Entergy Nuclear Northeast
Indian Point Energy Center
450 Broadway, GSB
P.O. Box 249
Buchanan, NY 10511-0249
Tel 914 734 6700

Re: Indian Point Unit 3
Docket No. 50-286
NL-04-156

Subject: **Reply to RAI Regarding Indian Point 3 Stretch Power Uprate dated
November 5, 2004 (TAC MC 3552)**

Figure RSA-8-1 RCSL Figure from Draft IP3 Cycle 14 COLR

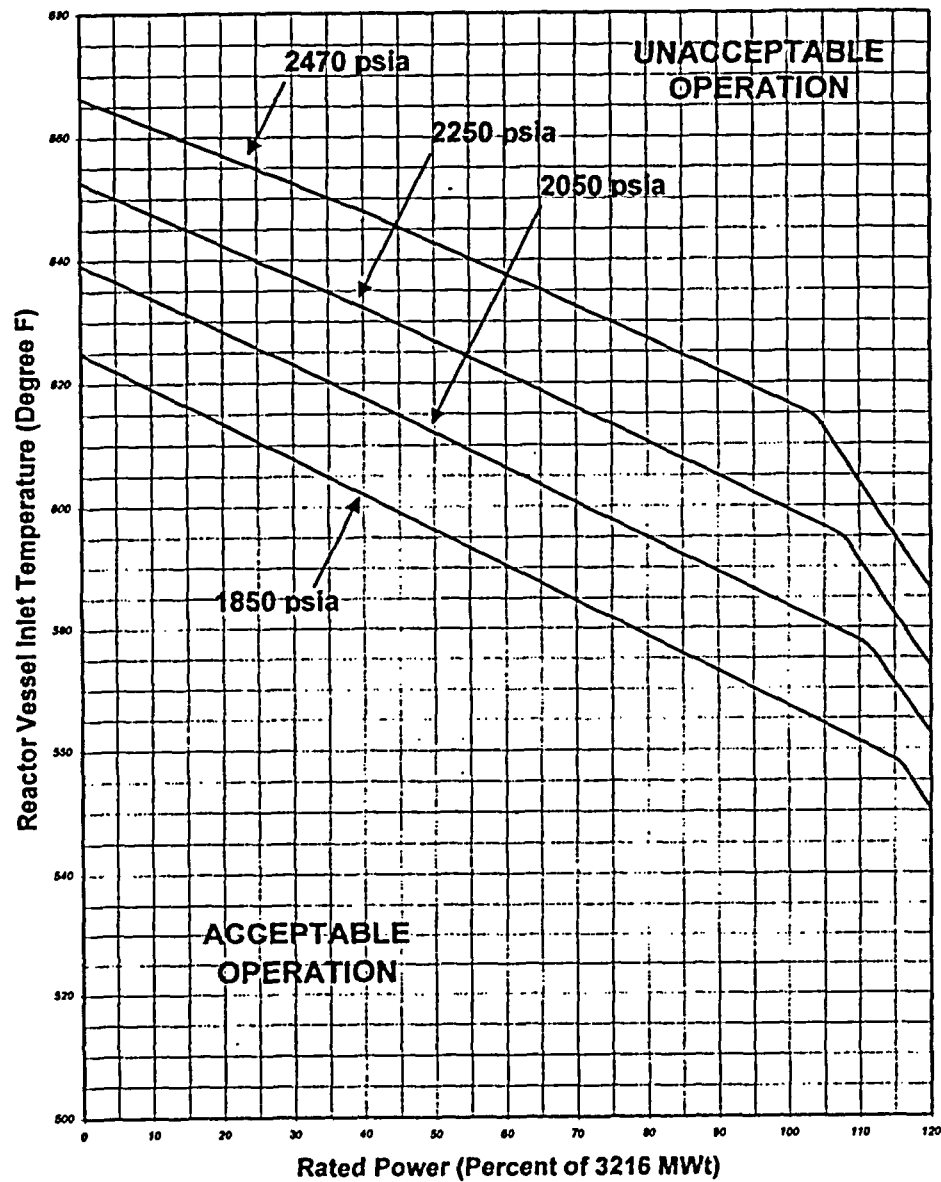
Many cycle-specific parameters have been relocated to the core operating limits report (COLR), which was not submitted with the application. These include the Reactor Core Safety Limit (RCSL) figure, the values of the constants in the Over-temperature and Over-power ΔT functions, respectively (Notes 1 and 2 in Table 3.3.1 1), and the limit values of the pressurizer pressure, RCS average temperature, and RCS total flow rate (limiting condition for operation (LCO) 3.4.1).

Provide the RCSL figure and the values of the constants of the OT ΔT and OP ΔT functions, and the RCS flow, average temperature and pressure limit values in the COLR, or confirm that they are the same as those provided in the application report.

A response to this question (except for the RCSL figure) was provided in letter NL-04-145 of November 18, 2004, in Attachment 2 in response to IP2 item NL-04-073-RSA-20. That response is provided below. The RCSL figure is provided as Figure 6.3-1 of WCAP-16212-P and WCAP-16212-NP and here as Figure RSA-8-1.

INDIAN POINT 3 FSAR UPDATE	
FLOW DIAGRAM	
SAFETY INJECTION SYSTEM	
SHEET NO. 2	
REV. 9 JUN 2000	FIG. NO. 6.2-1B

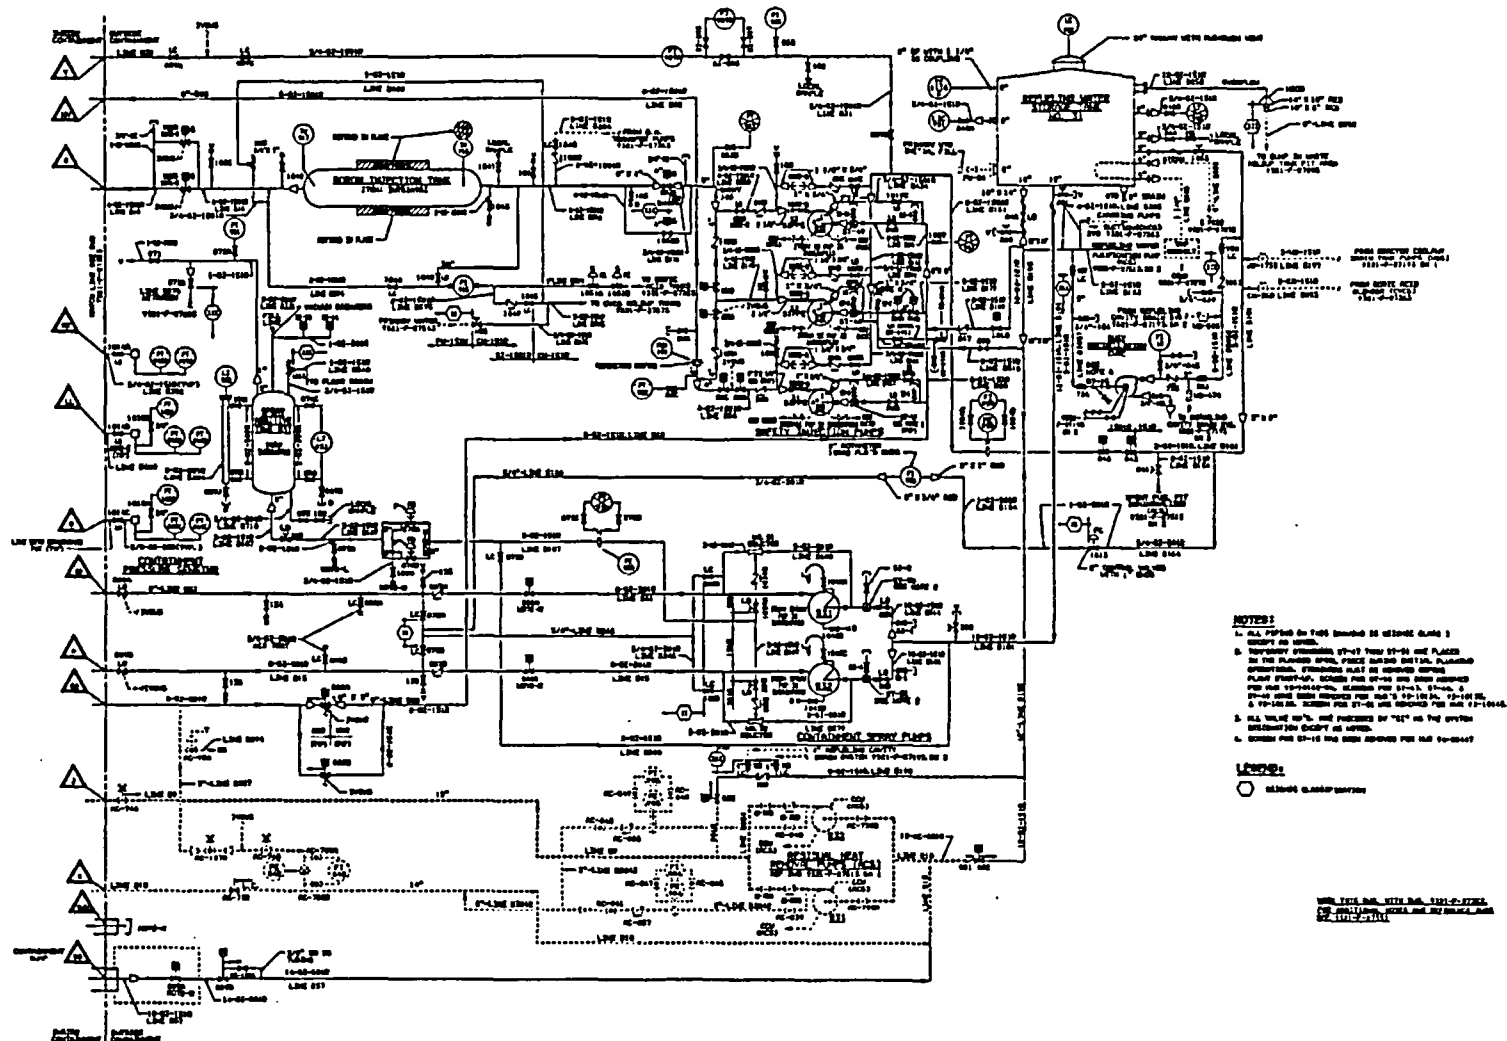
In Section 4.1.4 on the safety injection system/containment spray system of application report, the licensee states the high-head safety injection (HHSI) system was modified by permanently closing two cold leg branch lines, and throttling the HHSI system to provide higher cold leg and hot leg flows. What is the design function of the branch line? Why is it acceptable to defeat this

function permanently? Provide a system diagram which depicts the branch lines that were closed. Discuss how this is administratively controlled and how the redundancy and independence of the system was preserved.

The branch line piping connects the two HHSI pump discharge headers (typically called the 33/BIT and 31/non-BIT headers) to each of the respective reactor coolant loop cold legs and hot legs (i.e., there is no direct reactor vessel injection with this system design). For ease of discussion, a simplified diagram of the Indian Point Unit 3 HHSI system is provided in Figure RSA-12-1, while the attached Indian Point 3 UFSAR Figures 6.2-1A and 6.2-1B show the actual plant system diagram.

Revised HHSI system performance (both hot leg and cold leg performance) was calculated with the 856A and 856F manual valves permanently closed. This HHSI flow performance data was then used in the various accident analyses performed in support of the Indian Point 3 SPU program. The appropriate limiting single failures and spilling line (e.g., flow from branch line(s) connected to a broken loop may not be credited as safety injection flow to the reactor coolant system) assumptions were also applied in calculating the HHSI system flow performance data. The driving reason for permanently closing the 856A and 856F lines is to achieve higher hot leg recirculation flow performance, required to support the SPU program, while maintaining the maximum allowable HHSI pump flow limits.

Figures 6.2-1A and 6.2-1B are system diagrams provided in the Indian Point 3 UFSAR. A simplified figure of the system, showing the lines that are closed, is provided as Figure RSA-12-1 attached.

The 'permanently' closed valves will be administratively controlled by changing the normal position to locked closed. The valves can be re-opened and subsequently re-closed, as required, during plant shutdown to perform various surveillances on the remainder of the line(s)/components that will remain intact, and connected to the RCS pressure boundary.

Figure SI-1b-1: Probability of Correct Rejection/Reporting (PCR) Considering Only Passed Candidates, Appendix VIII from the Outside Surface. Reporting Criterion A' = 0.15 inch.

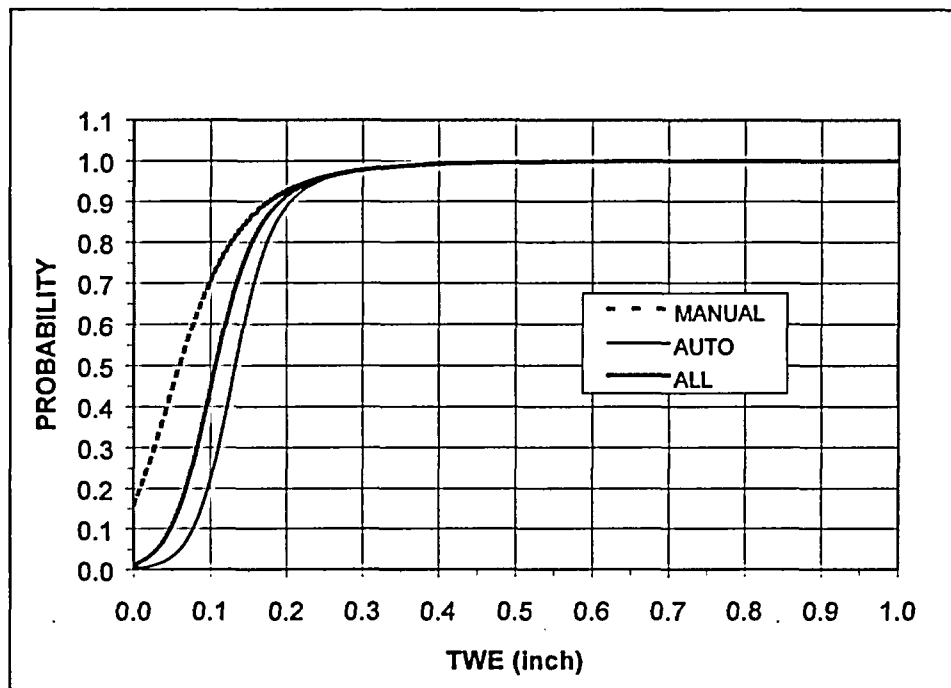
PVM-1 also requested the licensee to justify the use of a smaller flaw size for the RV outlet-nozzle-to-shell region. Table 5.9-4 of the IP3 application report indicates that smaller flaw sizes than those specified in Appendix G of Section XI of the ASME Code were used for the steam generator tubesheet and shell junction, steam outlet nozzle, and feedwater nozzle. Provide a justification for using the smaller size flaw or provide an analysis using the flaw sizes and margins described in Appendix G of the Section XI of the ASME Code.

The PODs for the steam generator tubesheet and shell junction, steam outlet nozzle, and feedwater nozzle can be taken from EPRI Report, "Justification for the Reduction of Inspection Requirements for the Boiling Water Reactor Nozzle-to-Vessel Shell Welds And Nozzle Blend Radii (VIP-108)", R. Carter, June 2002. This report is deemed applicable as the inspection technique would be the same for Steam Generators and applicable for regions with wall-thickness less than 11 inches. As shown in the following figure, the PODs of flaws with depth greater than 0.5-inch is approximately 100% (manual OD volumetric).
